## DDEC<sup>®</sup> V SECM Service Information

NUMBER: 08 DDEC V-1

SUBJECT: TROUBLESHOOTING FLASH CODE 51, PID 351/FMI 3

PUBLICATION: DDC-SVC-MAN-0012

**Figure 1 TCI Sensor and Connector**

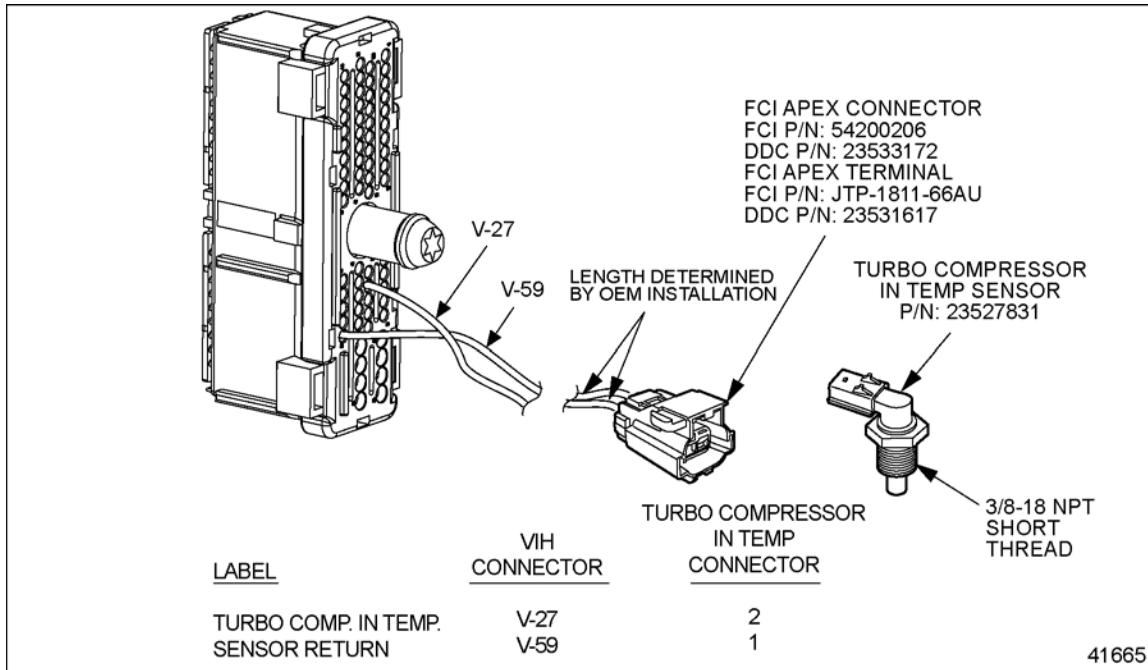
Section	Change
51.2.1 TCI Sensor and Connector graphic	Sensor return has been updated to V-59
